Re: Planning Application to An Bord Pleanála for Proposed 220kV substation, associated 220kV underground grid connection, cabling and associated works on a site of 1.8 hectares at Toomes and Monvallet, County Louth.

Application ref: ABP-315456-23

Malone O'Regan Environmental has been commissioned by Strategic Power Projects Limited to prepare an Addendum to the Environmental Report (ER) that was submitted in support of a SID application (Reference 315456-23) in support of a response to An Bord Pleanála letter dated 31st July 2023.

05895-DR-201

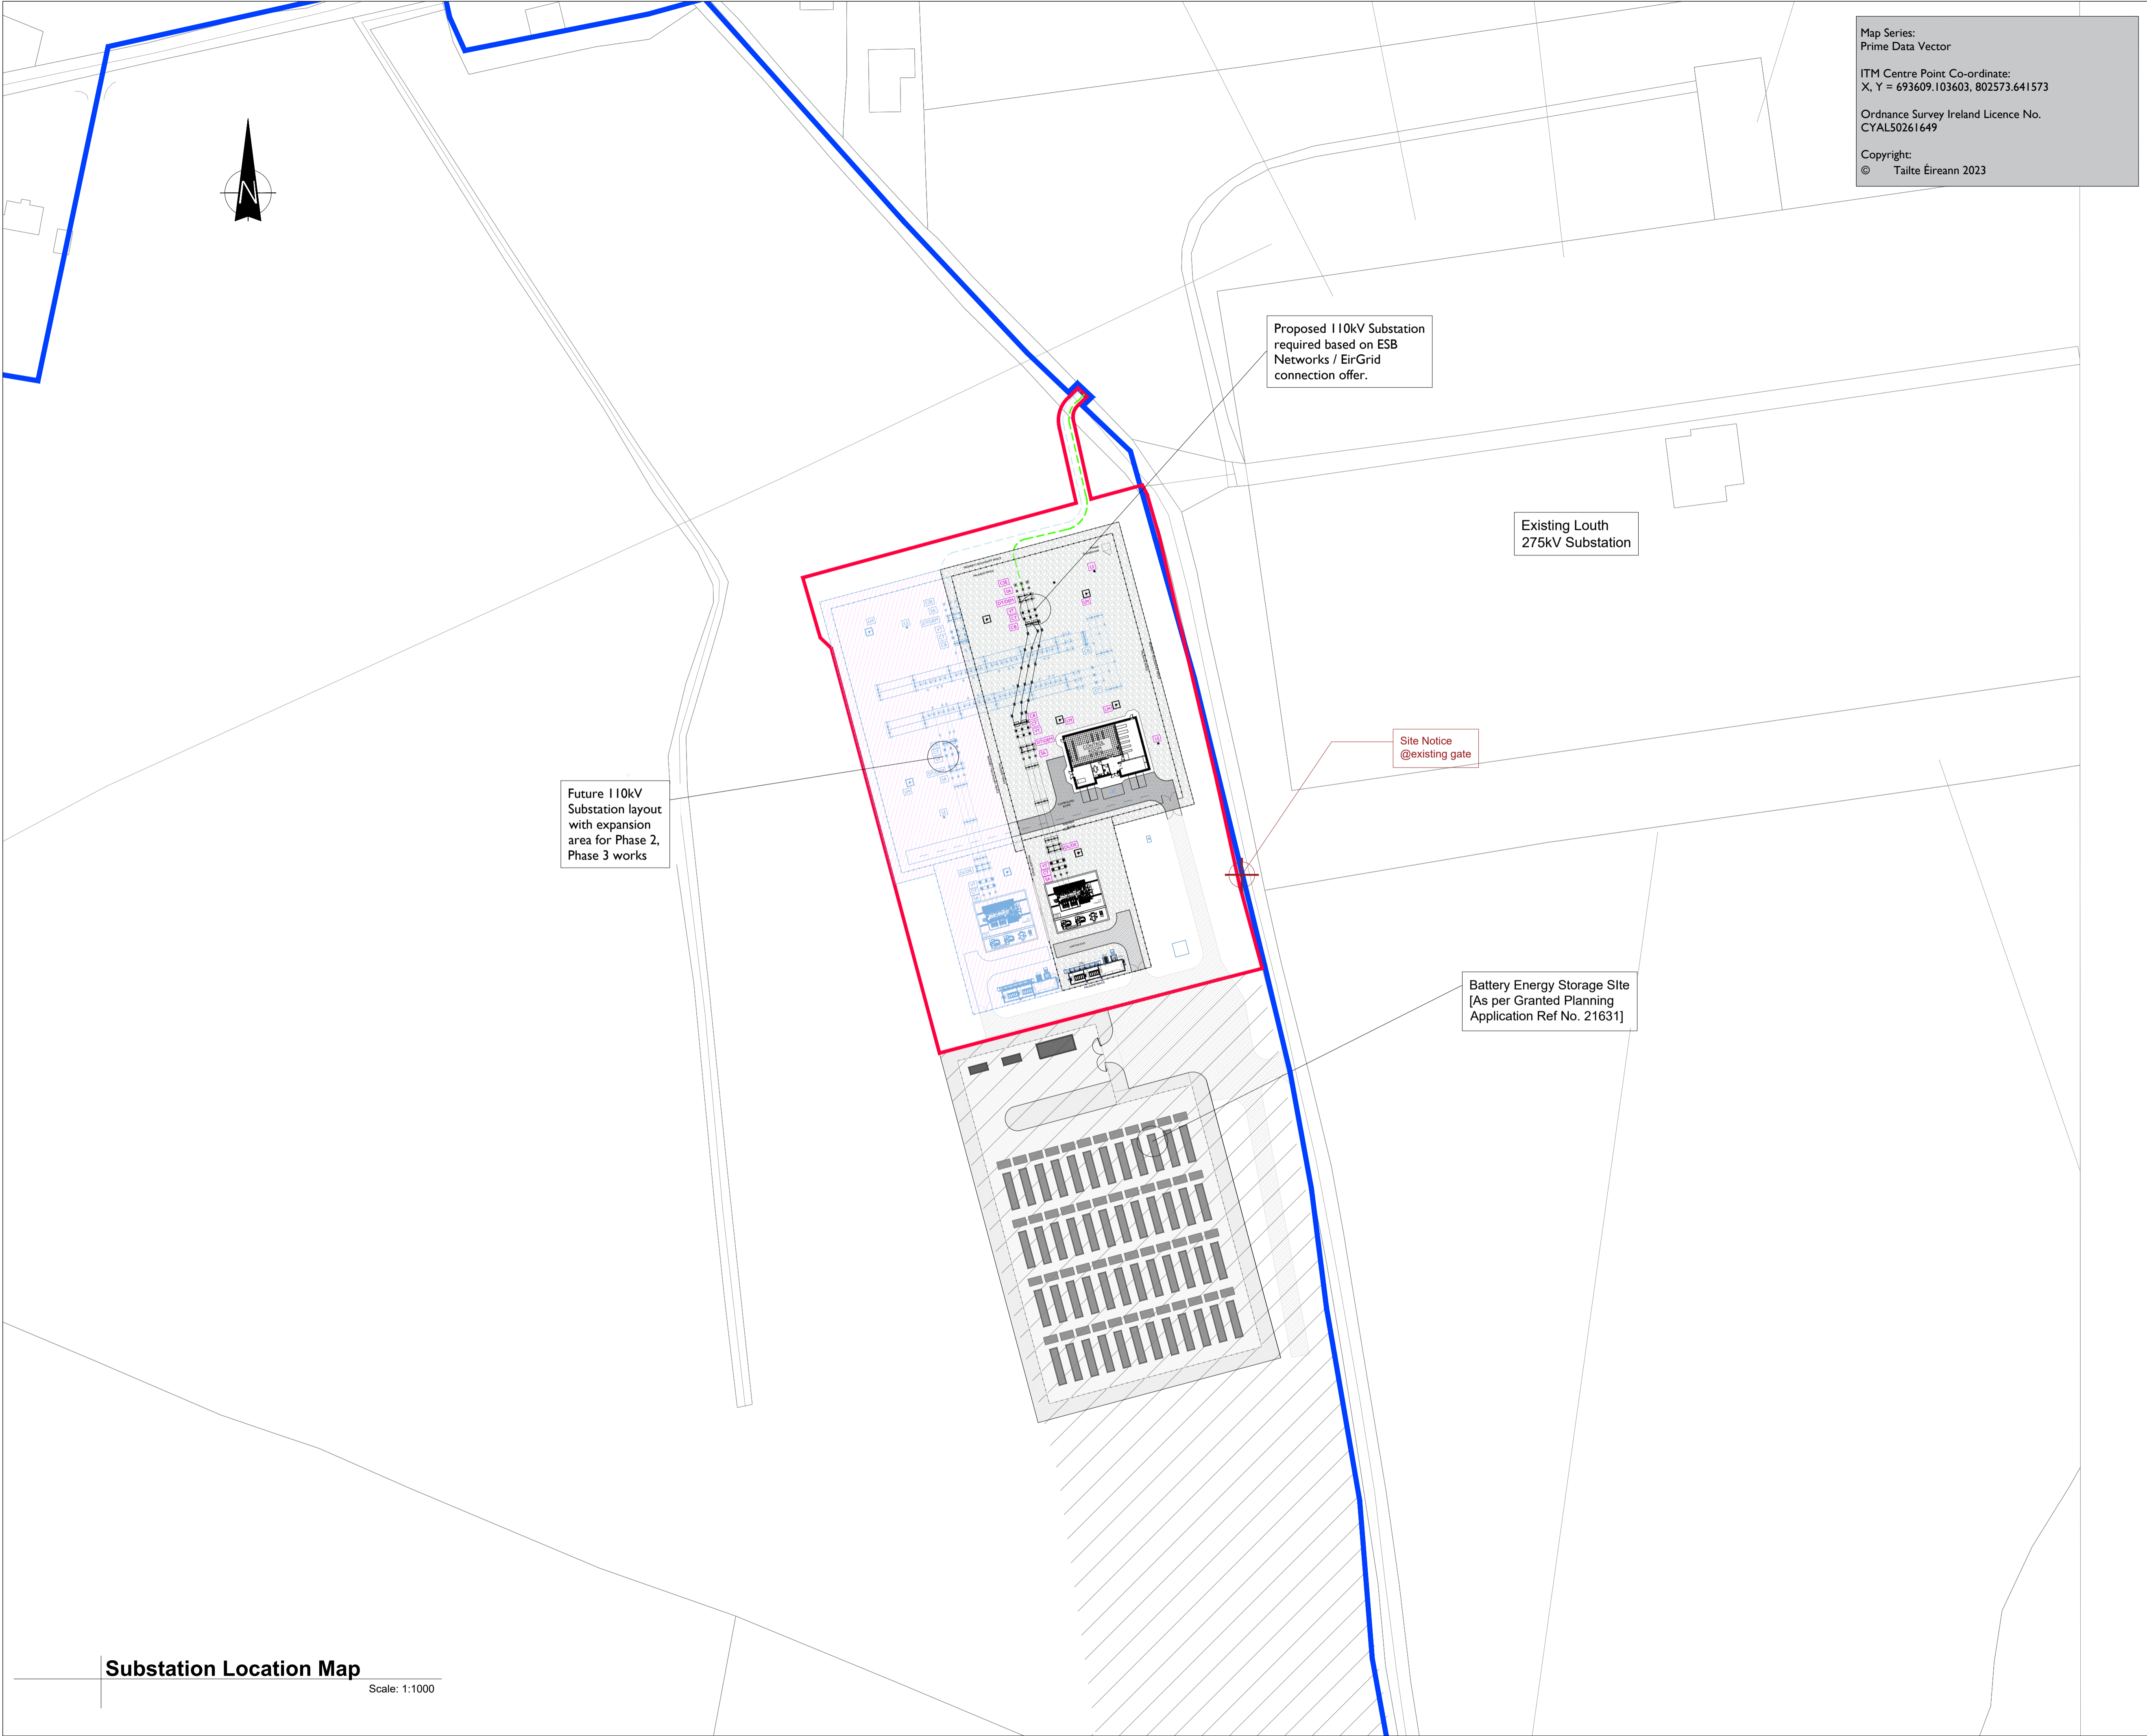
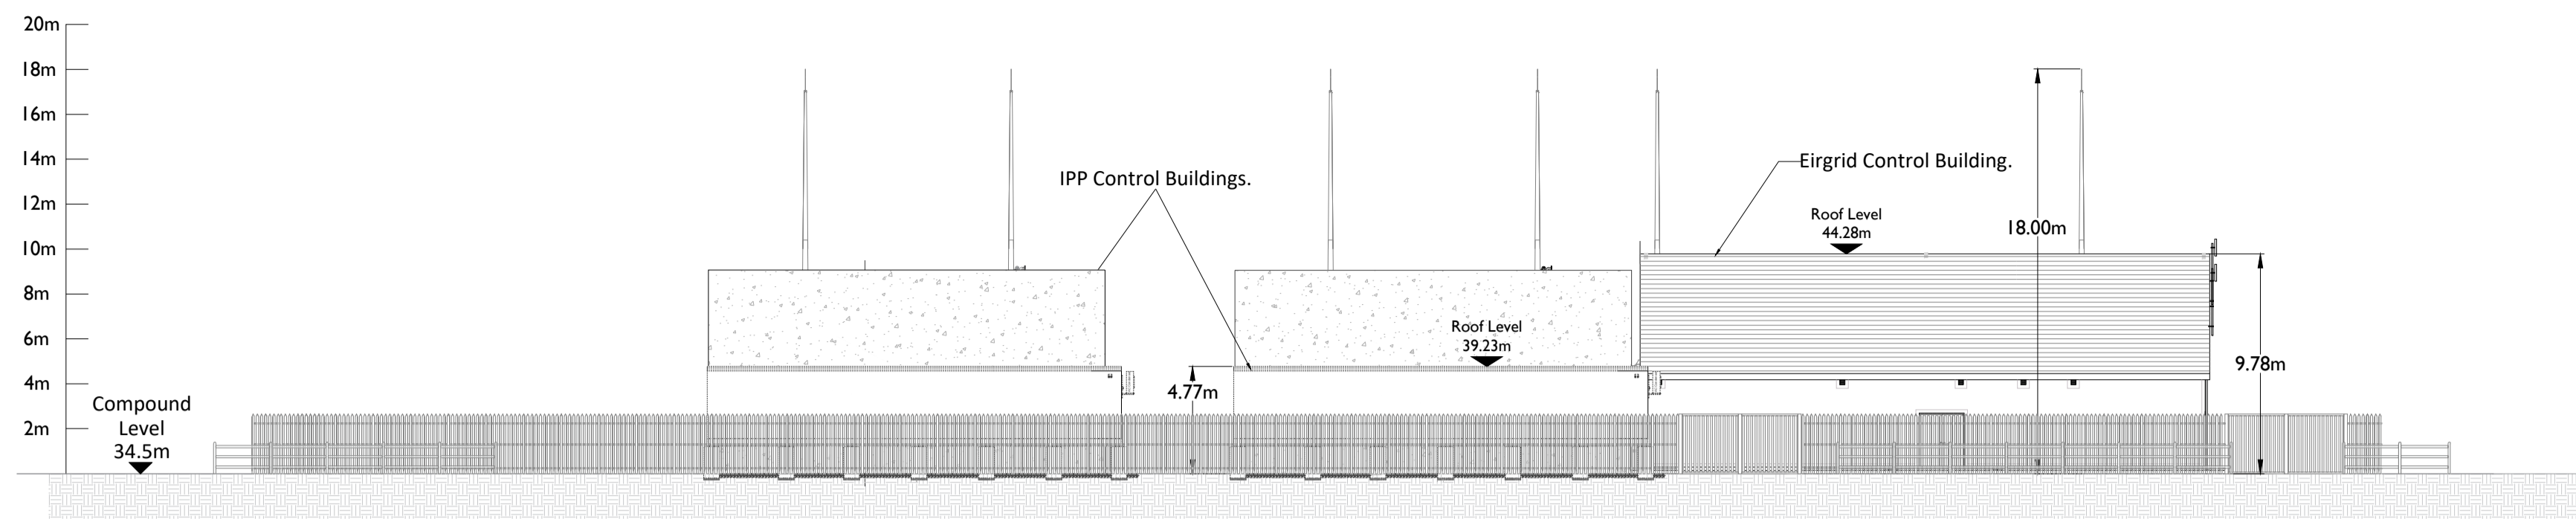
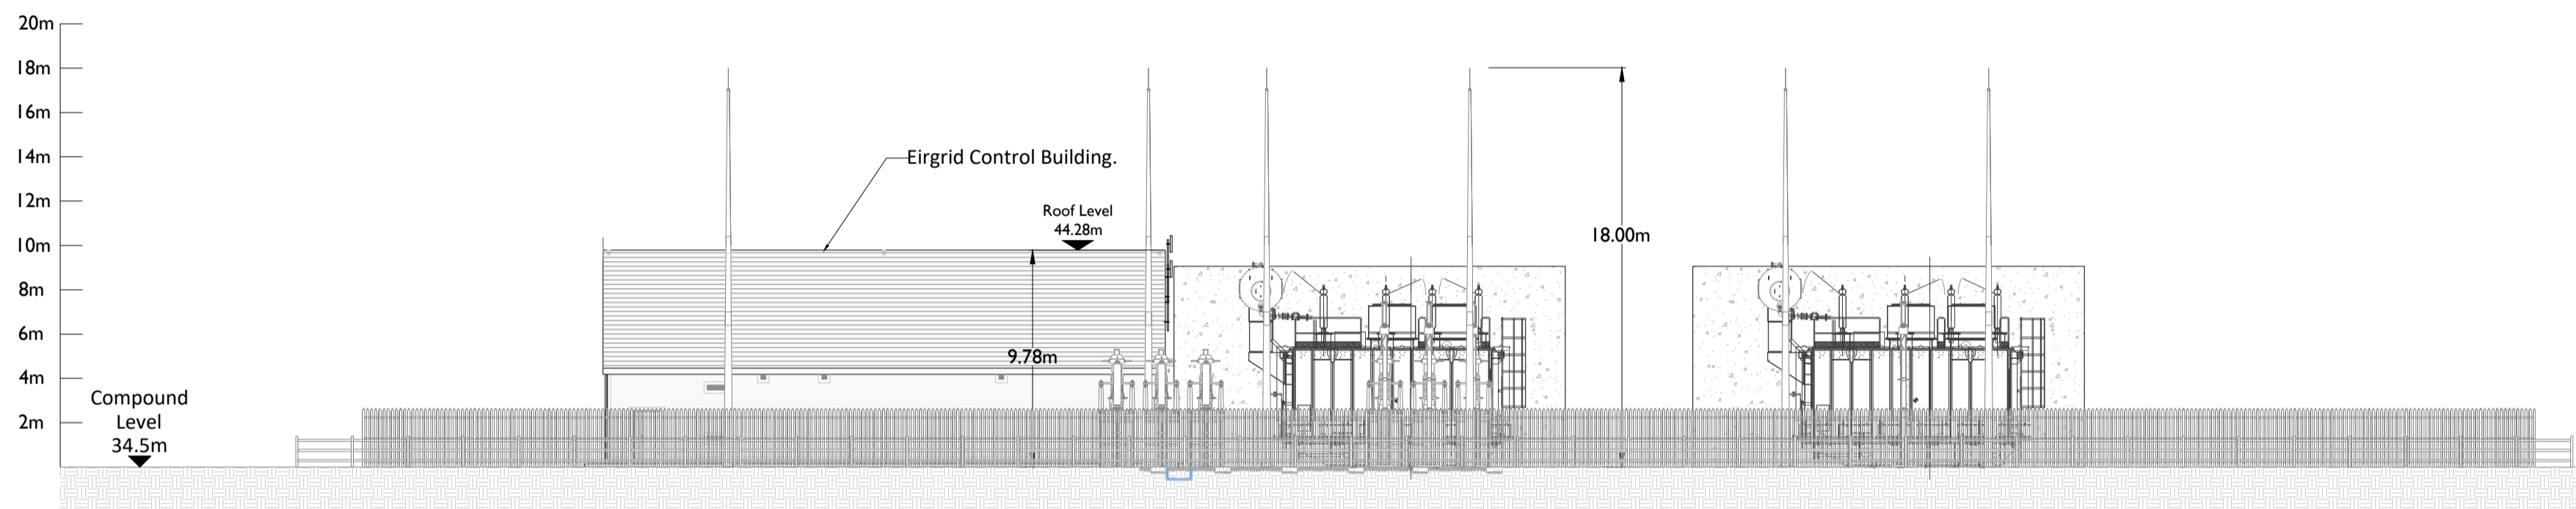
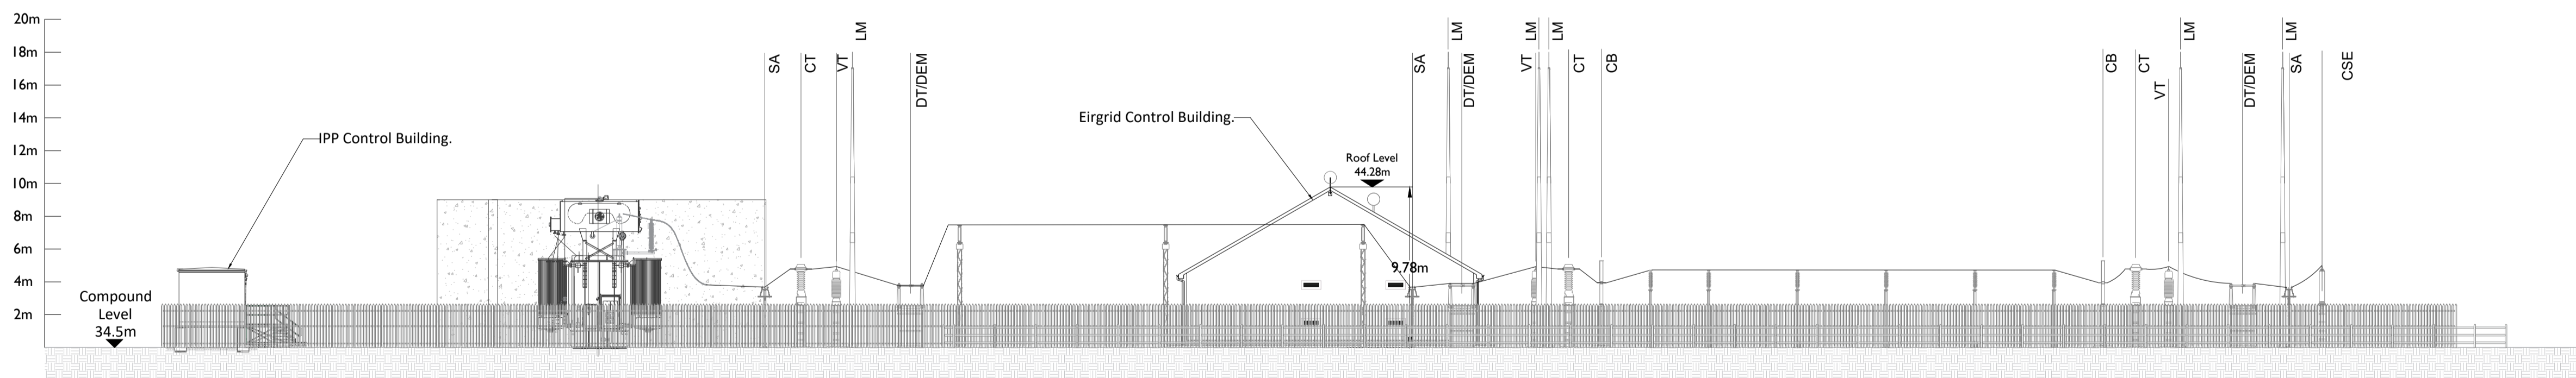
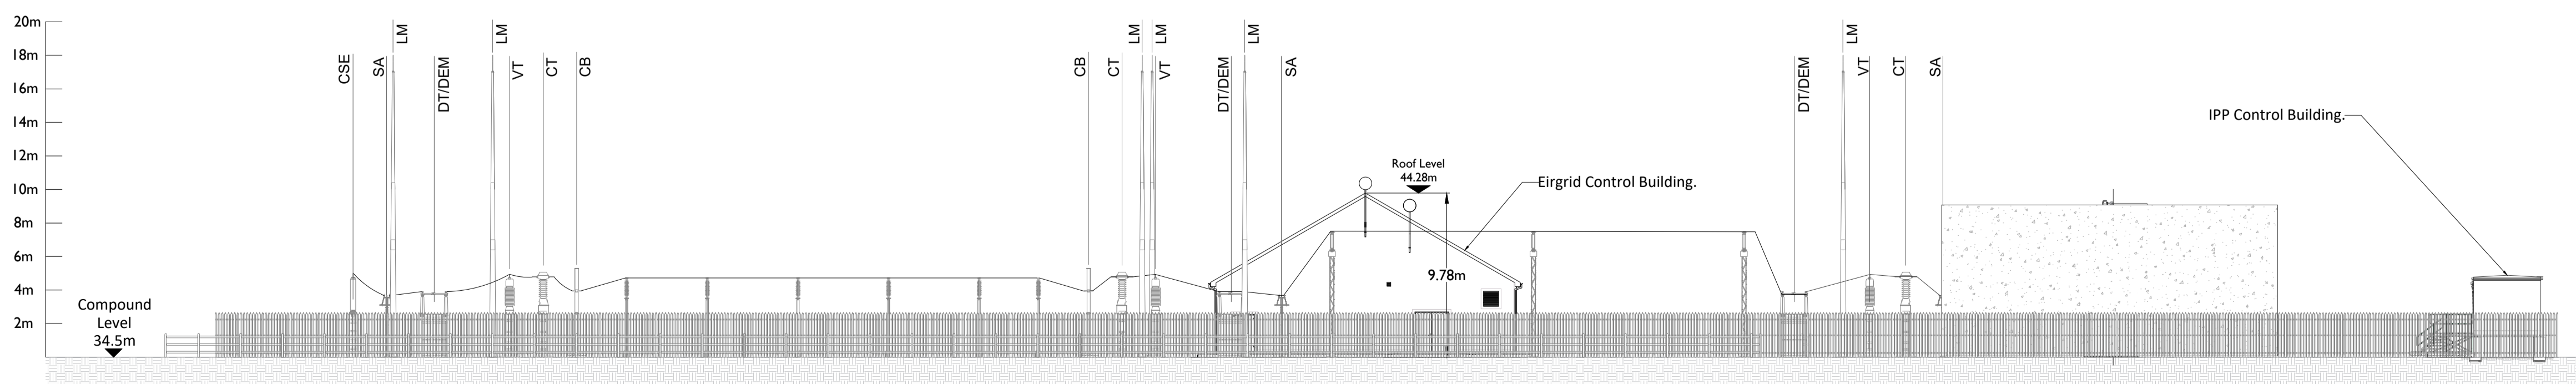
In response to the TII submission, we wish to present an alternative design proposal to the Board for their consideration, that would negate the requirement for any oversized loads on the national road network. This alternative design would be based on the installation of 2 No. 110kV substations instead of 1 No. 220kV substation. This alternative design proposal should the Board be willing to permit it would match the 220kV power capacity of the current proposal, but it would just be delivered via a different design arrangement. As there would no longer be a 220kV transformer, the requirement for the specialist commissioning equipment and associated oversized loads would be negated.

Additionally, the footprint layout and design of 2No. 110kV substations, as per the alternative layout and design, is not materially different to the 2 x 37kV substations already permitted on this site under (Planning Ref: 21/631). The suggested alternative would simply be built instead of the 2 x 37kV substations. The footprint, layout and design of a single 110kV substation is also not dissimilar to that of the 220kV substation.

Figure 1-1: Development Overview

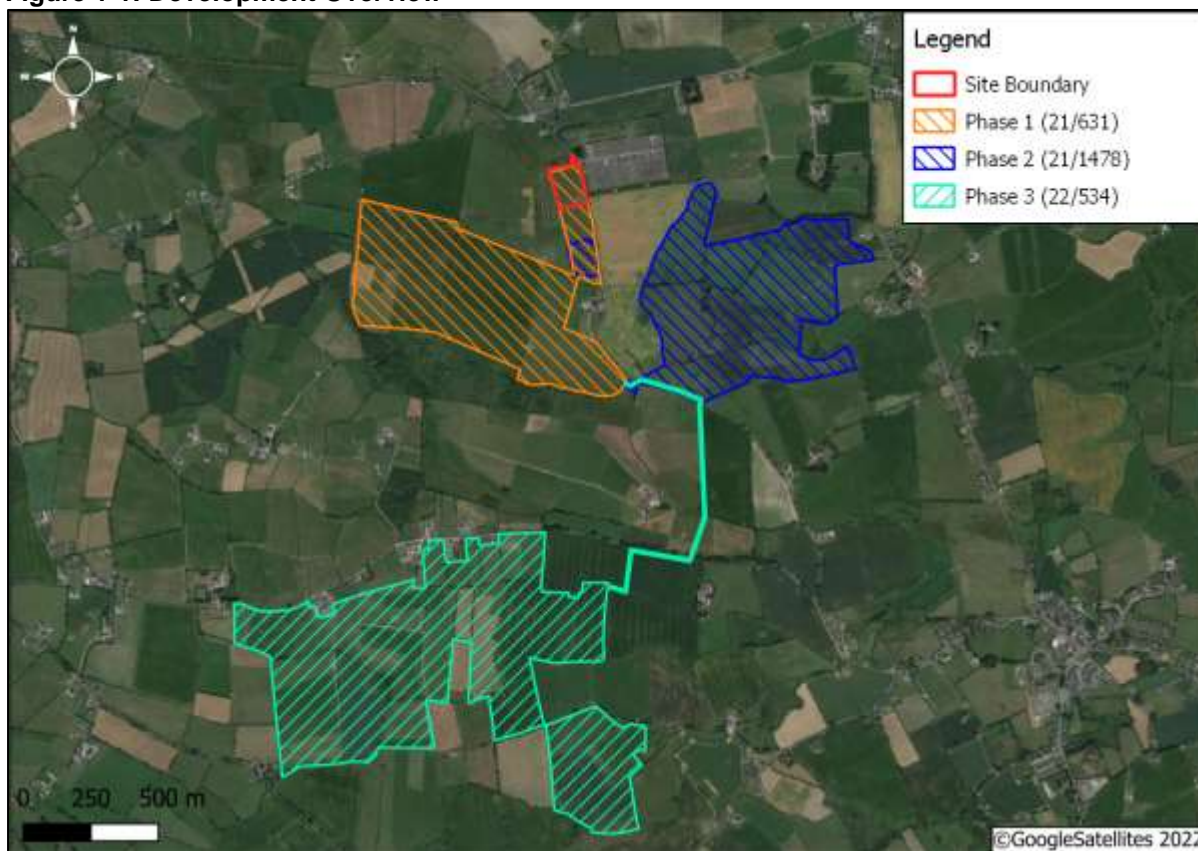
Original Environmental Report	Changes in the proposed amendment of the energy system
Redline Boundary	No Change
1No. 220kV substation	2No. 110kV substations
1No. IPP building (with satellite dish attached) measuring ca. 9.9m x ca.19.3m x 8.0m (height)	2No. IPP buildings (modular steel construction) measuring 18.5m x ca.5.5m x ca.4.9m (height)
1No. EirGrid Control Building measuring ca.11.7m x ca. 13.0m x ca.6.8m (height)	1No. EirGrid Control Building measuring ca. 25m x ca.18m x ca. 3/8m (height)
1No. Power Transformer and 1No. House Transformer (House TX).	2No. Power Transformers, 1No. House Transformers (House TX). 2No. Auxiliary Transformer.
1No. interface kiosk	2No. Interface kiosk
3No. lighting masts and 7No. lamp standards	9No. lighting masts and 12No. lamp standards
1No proposed underground cabling (220kV) and ducting which will extend from the substation site to the existing ESB substation	2No. proposed underground cabling (110kV) and ducting which will extend from the substation site to the existing ESB substation
